Red = proposed additions Struck-out = proposed deletions

Numbers after additions & deletions refer to Comments in August Matrix [1 - 222] ; [E] refers to EPC Comments; [S] refers to Staff Recommendation

C. Traffic Movement, Access Management, and Roadway Design

Figure C-3: Example 6-Lane Typical Sections with CURBSIDE Bus/BRT Lanes for COORS BOULEVARD/COORS BYPASS (NM45)

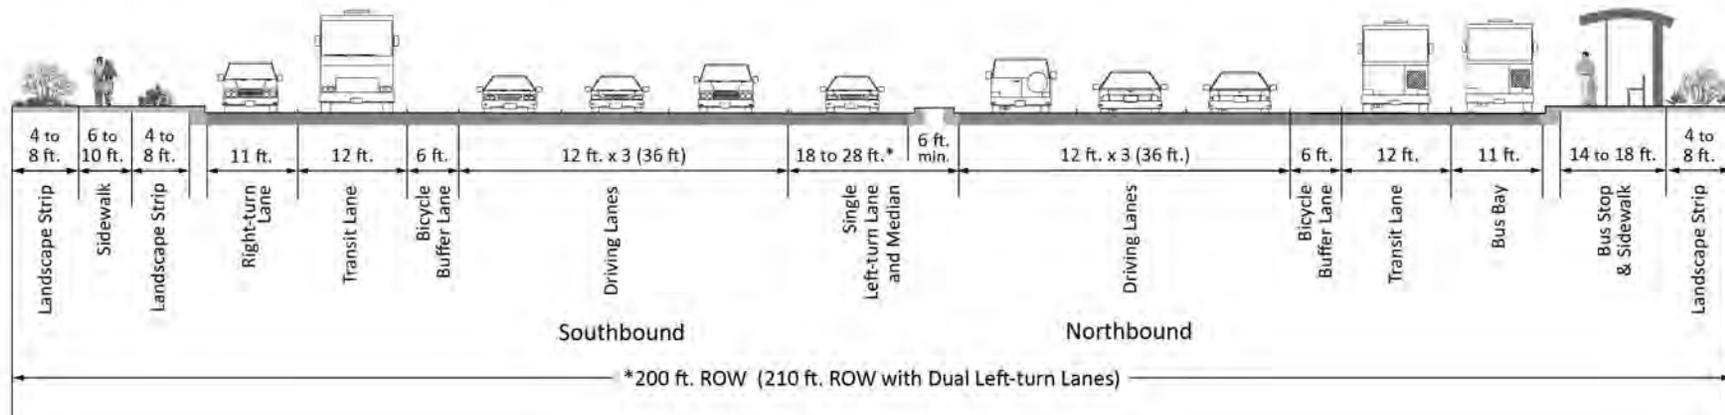
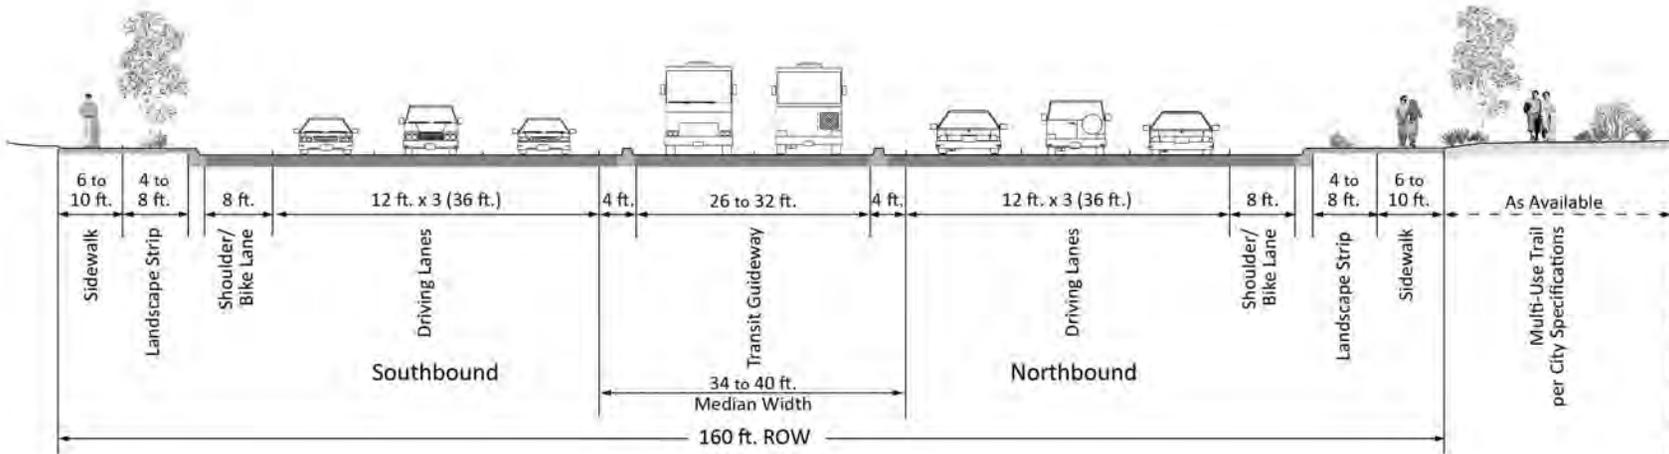
B. Section at Intersection with curbside BRT Station (see 4.2) [37]

Figure C-4: Example 6-Lane Typical Sections with MEDIAN BRT Lanes for COORS BOULEVARD/COORS BYPASS (NM45)

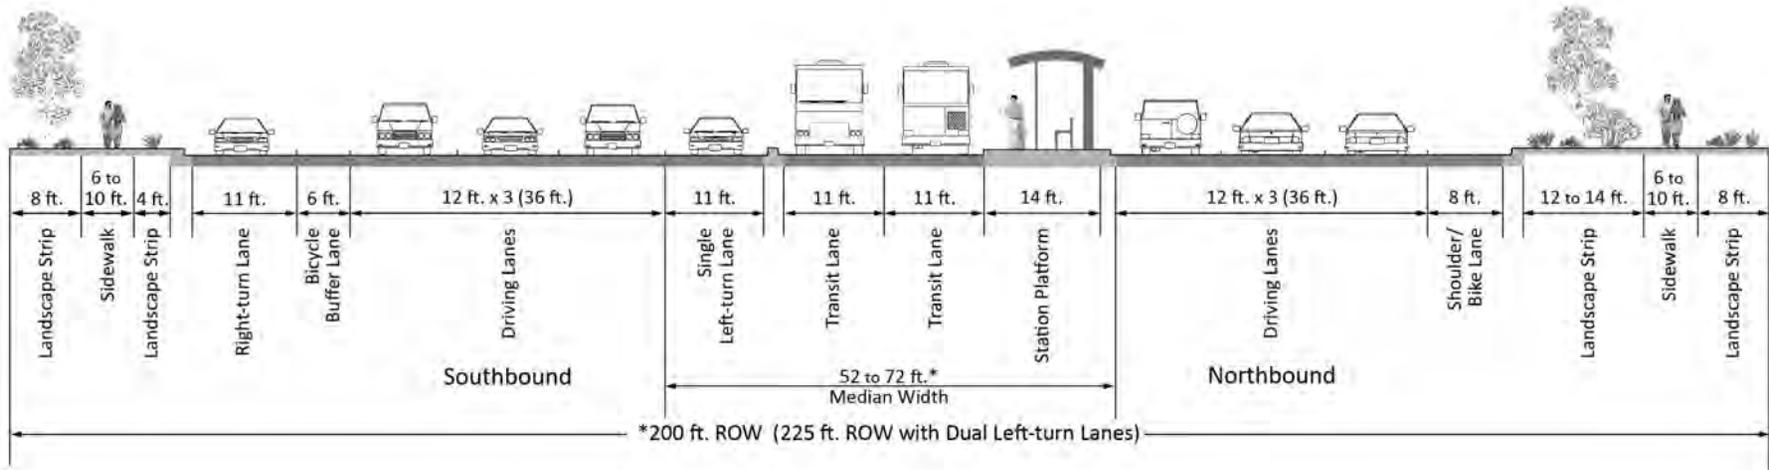
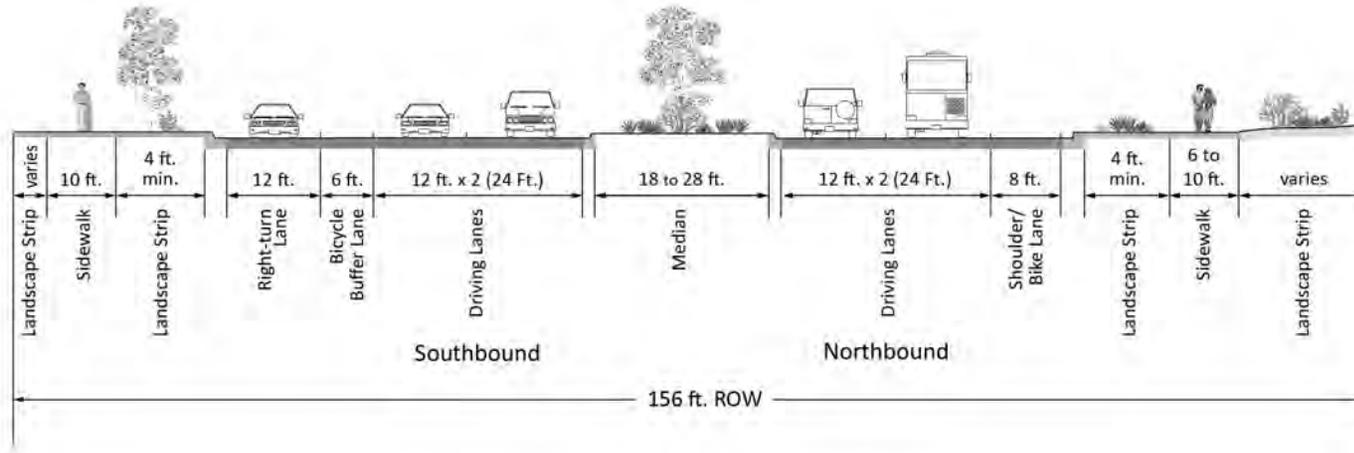
B. Section at Intersection with Median BRT Station (see 4.2) [37]

Notes: 1) Minimum 10 foot sidewalks are required in Major Activity Centers and Community Activity Centers as defined in the Albuquerque/Bernalillo County Comprehensive Plan. 2) Transit vehicles also use southbound driving lanes. [31]

Figure C-8: Conceptual New Flyover Ramp at Paseo del Norte

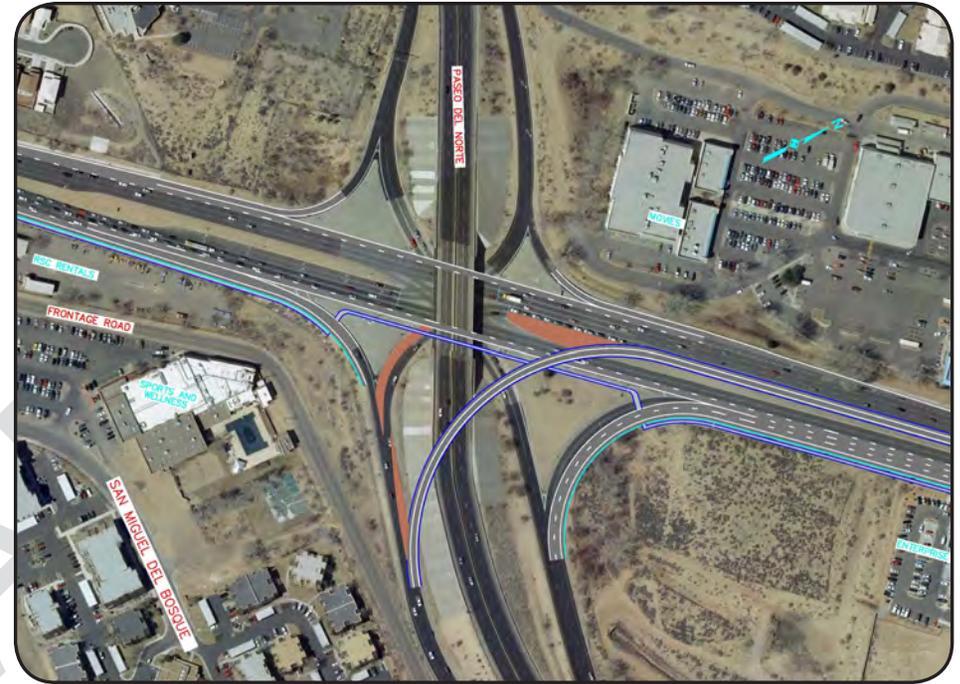
- i) Montaña Road [see concept in Figure B-8]: A single-point diamond interchange with Coors Boulevard as the continuous roadway would improve traffic operations and is consistent with the long-range plan for this intersection. Additional access controls would be required on each approved leg. **The NMDOT may consider an alternative design concept to Figure C-8 such as running Coors Blvd. under Montaña Rd.** [
